DESIGN COMMISSION REGULAR HYBRID MEETING AGENDA

TITLE:	DCB 25-04: Design Standard Review (DSR) 24-004 Study Session for Herzl Ner-Tamid Conservative Congregation Preschool-8 Project	<input checked="" type="checkbox"/> Discussion Only <input type="checkbox"/> Action Needed: <input type="checkbox"/> Motion <input type="checkbox"/> Recommendation
RECOMMENDED ACTION:	N/A

On April 4, 2024, the Applicant applied for a study session with the Design Commission to review a proposal to construct a three-story, mixed-use building, housing a preschool and K-8 private school on the lower levels and rental office space on the upper level and a half. Parking, trash, utilities, and pedestrian paths are located on adjacent parcels owned by Herzl Ner-Tamid Conservative Congregation (HNT). Applicants for Design Commission Design Review are required to take part in a study session with the Design Commission prior to public hearing pursuant to Mercer Island City Code (MICC) 19.15.220(C)(2)(a); this study session fills this requirement.

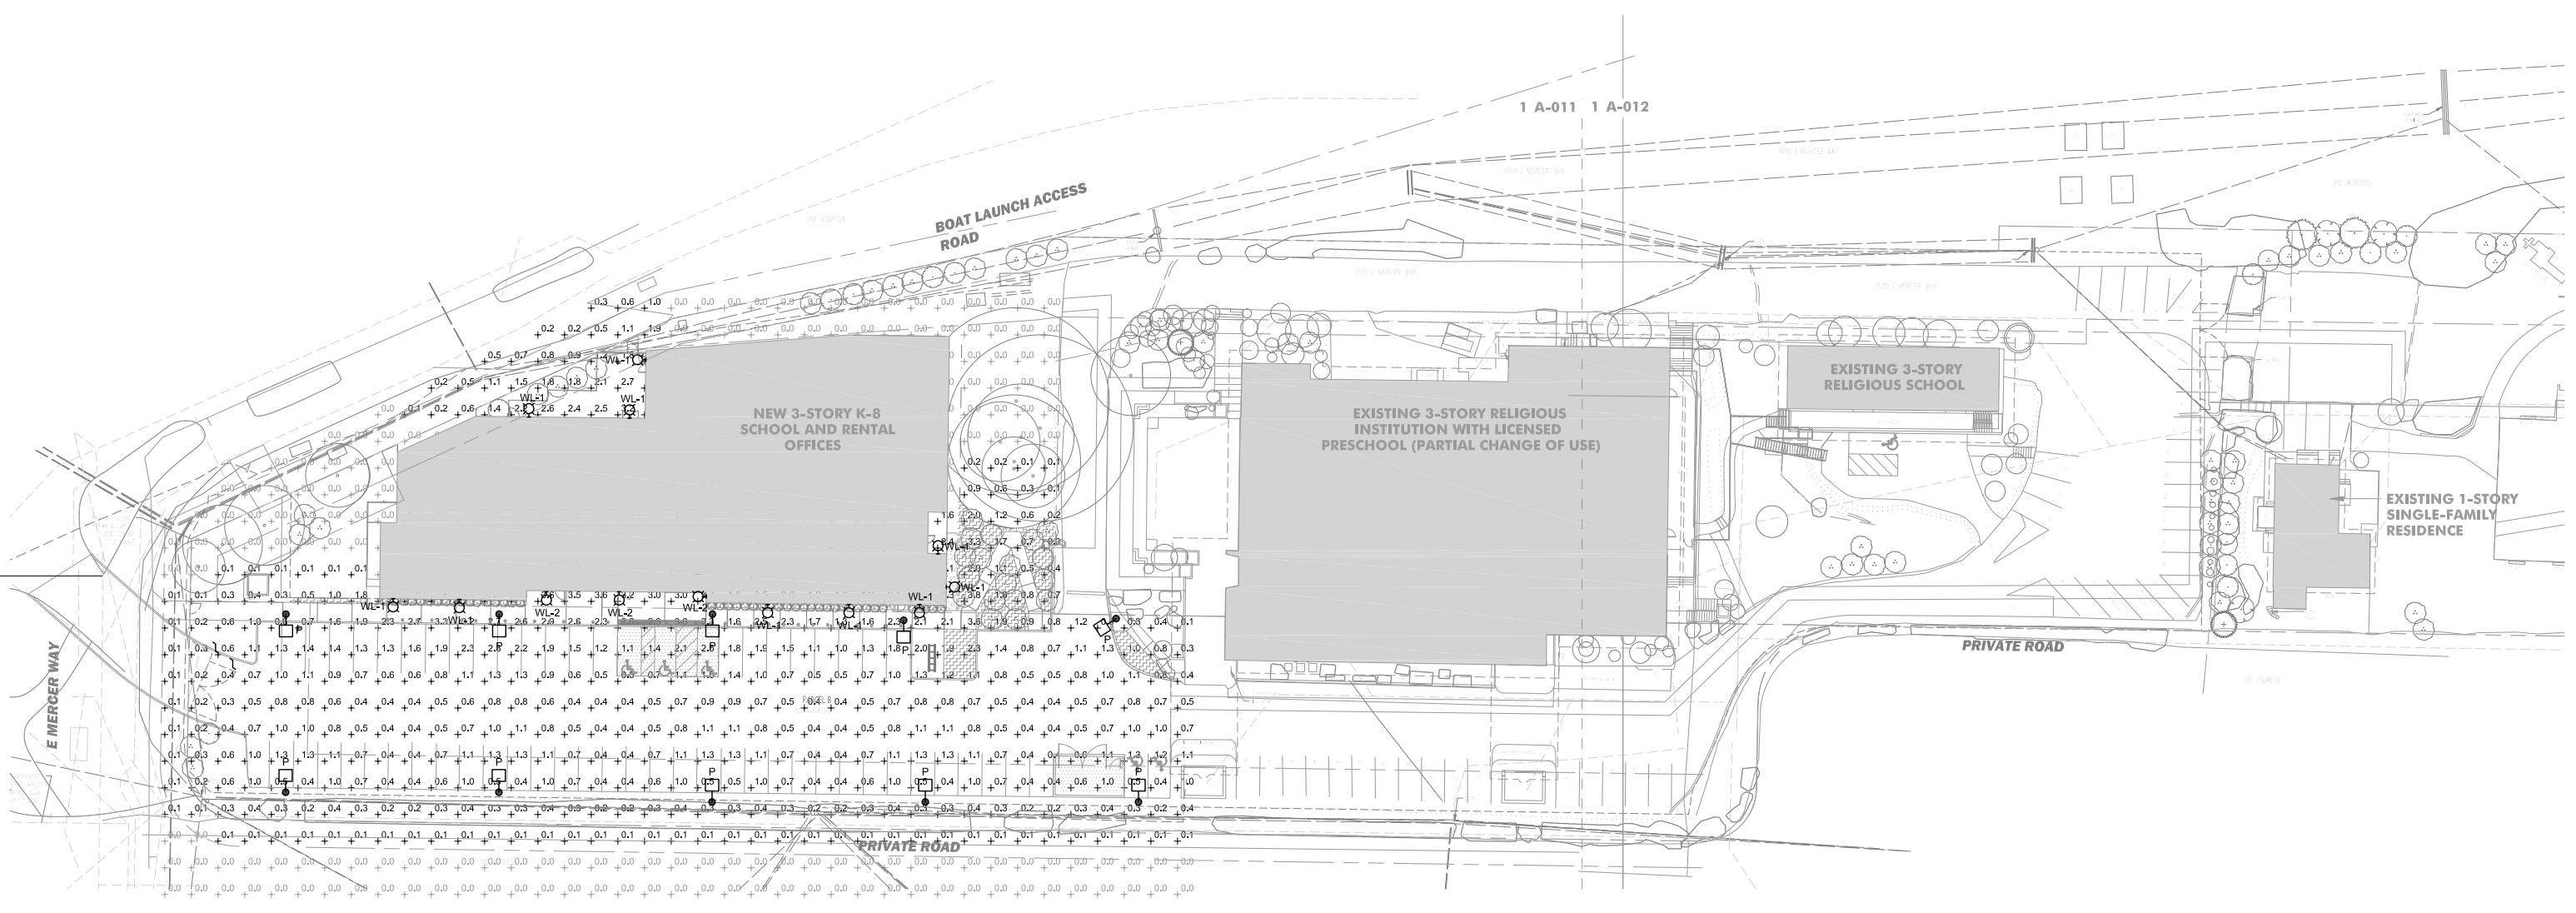
Preliminary Staff Analysis: The Applicant will be required to demonstrate that the building entrance would be well lit. Building mounted lights are proposed. Sheet E-102 of the plan set shows the subject property lighting photometric calculations.

Preliminary Staff Analysis: The Applicant must demonstrate that the exterior lighting fixtures would be shielded or located to confine light spread within the subject property boundaries. Sheet E-102 of the plan set shows the lighting photometric calculations.
